**Clinton Keith Road Construction Project – Phase 2  
From Whitewood Road to Leon Road  
In the City of Murrieta and French Valley Area  
Project No. B2-04722**

**CONTRACTOR QUESTIONS AND RESPONSES**

#### ADDENDUM NUMBER 6

Clinton Keith Road Construction Project – Phase 2  
From Whitewood Road to Leon Road  
In the City of Murrieta and French Valley Area  
Project No. B2-04722

CH2MHILL ENGINEERING COMPANY	SOLAR LIGHTING	SHEET
APPROVED BY  PROJECT MANAGER DATE APRIL 14, 2015	CLINTON KEITH ROAD FROM WHITEWOOD ROAD TO LEON ROAD	121 of 191
DESIGNED BY CHECKED BY	PROJECT B2-0472 ARCHIVE NO.	962-W

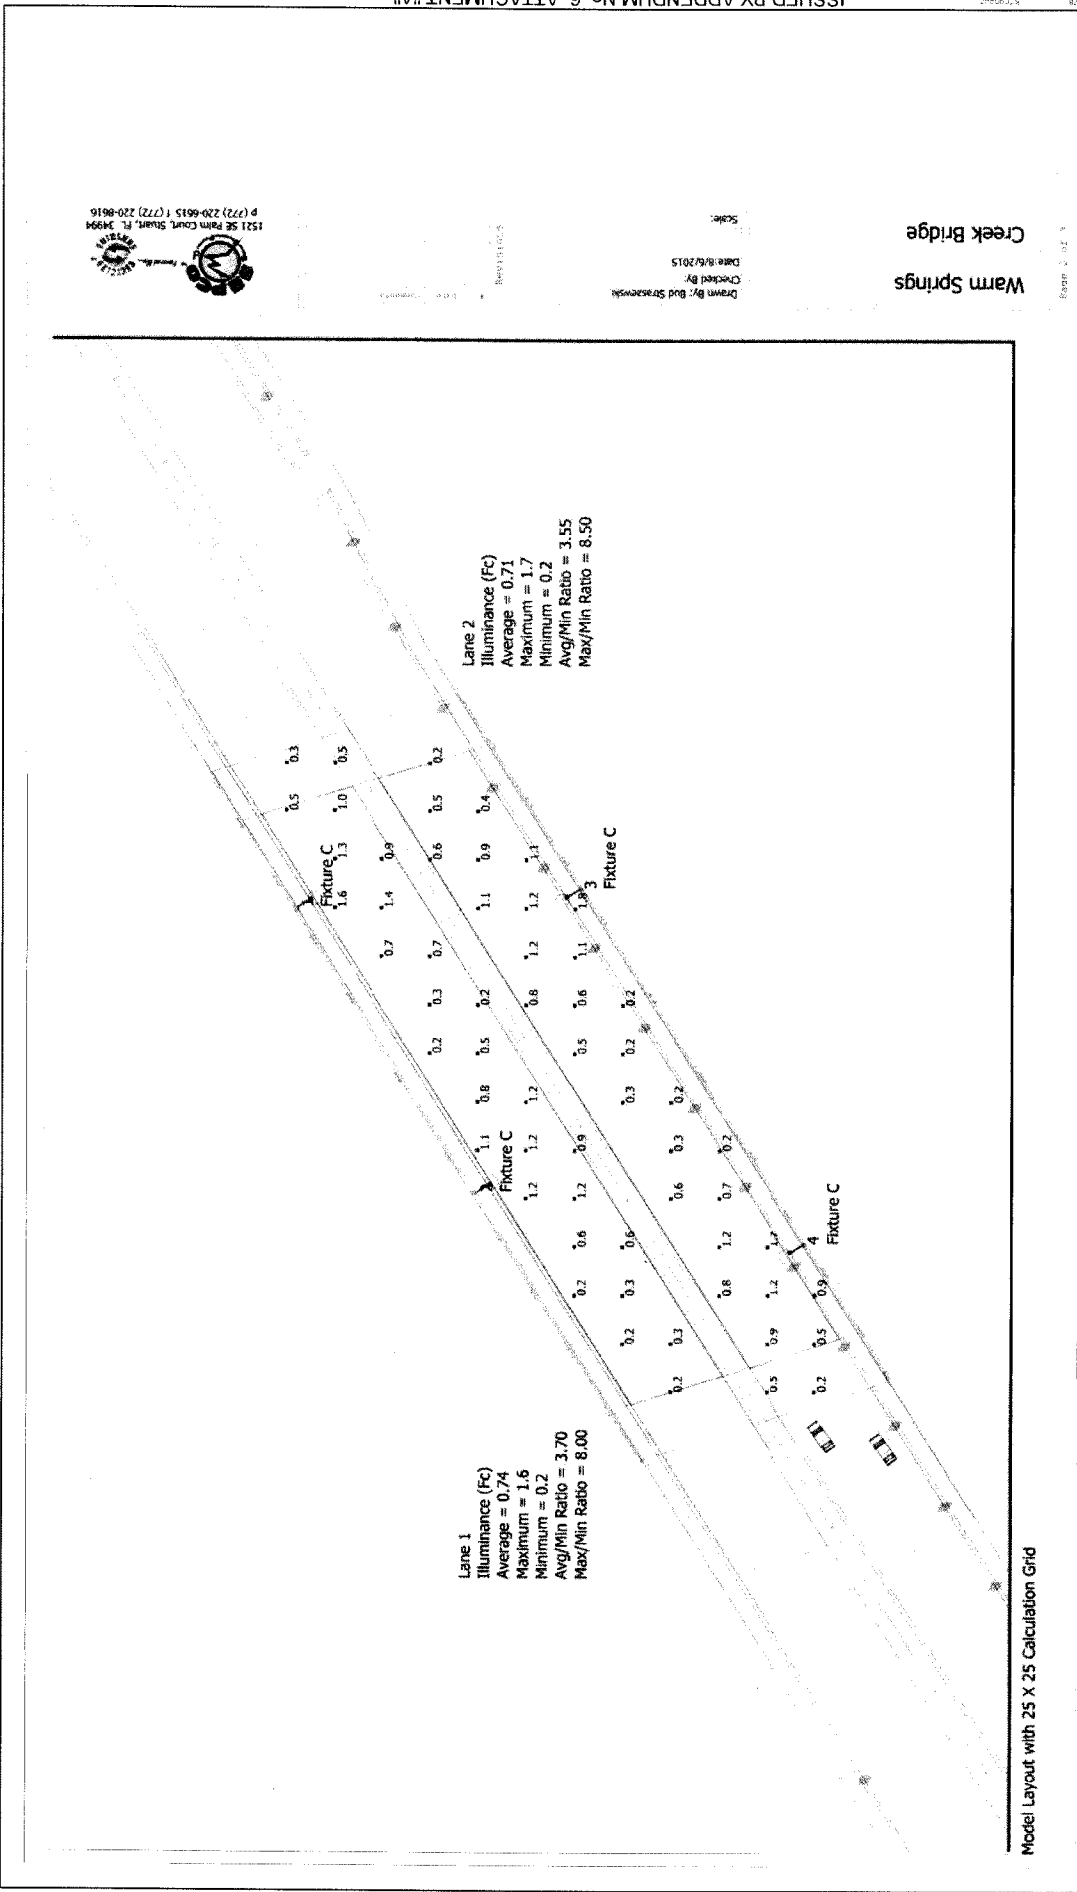
6 REVISED PER ADDENDUM No. 6

FENCE PLAN	SHEET
CLINTON KEITH ROAD FROM WHITWOOD ROAD TO LEON ROAD	98 of 195
PROJECT B2-0472 ARCHIVE No.	962-W

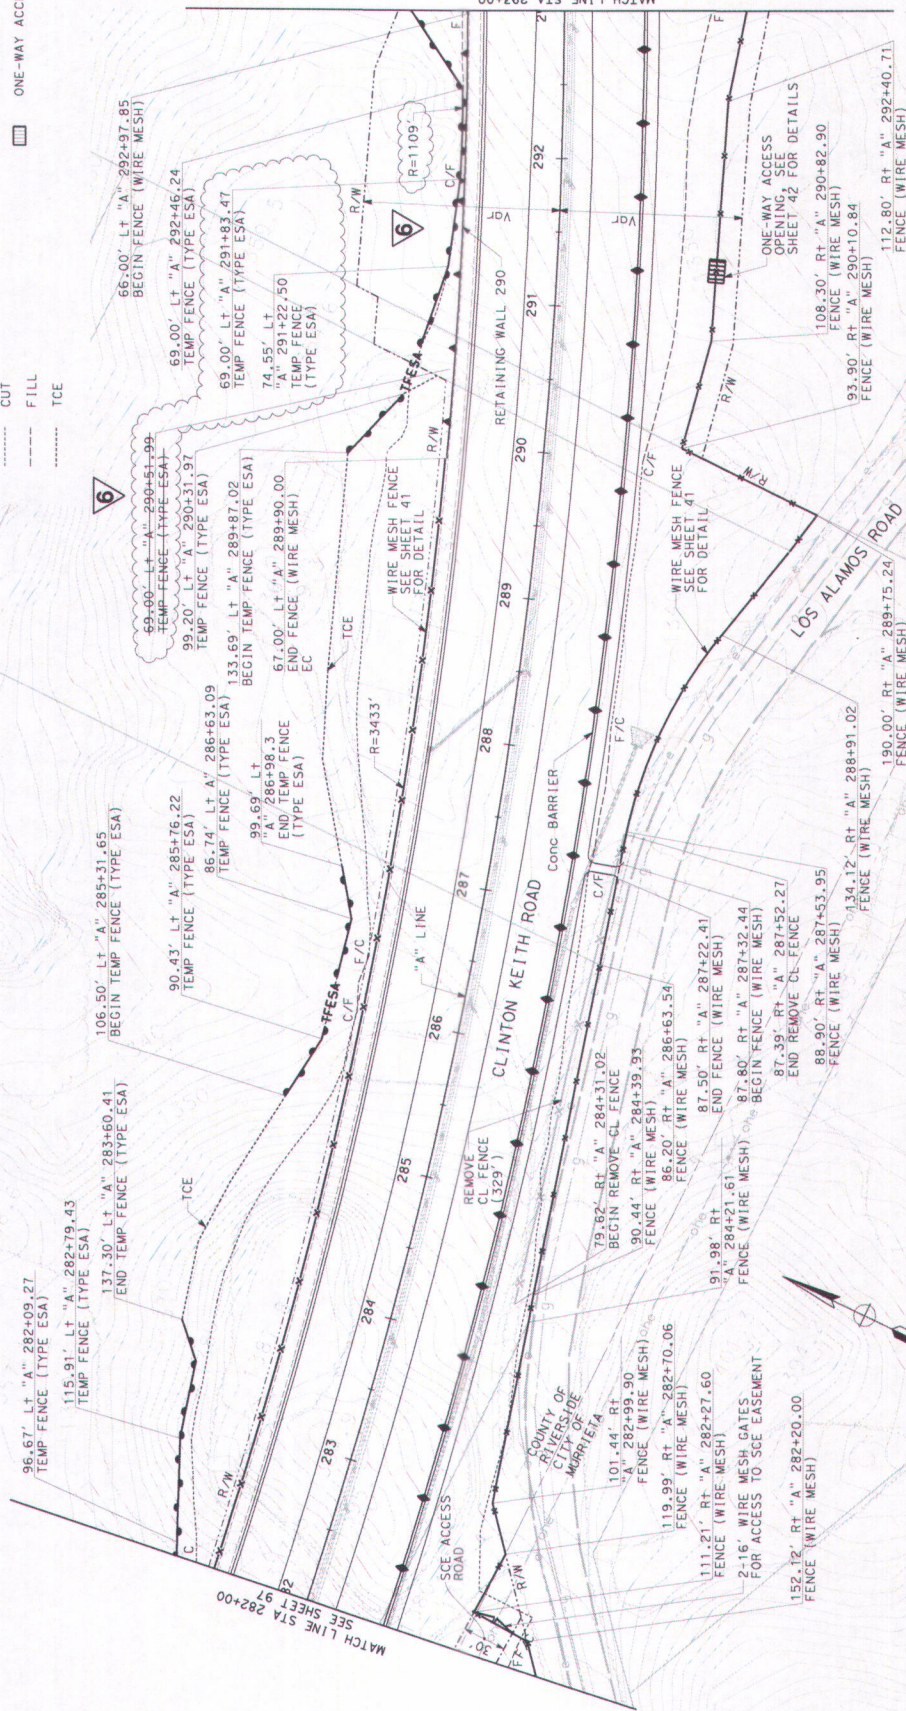
6 REVISED PER ADDENDUM No. 6
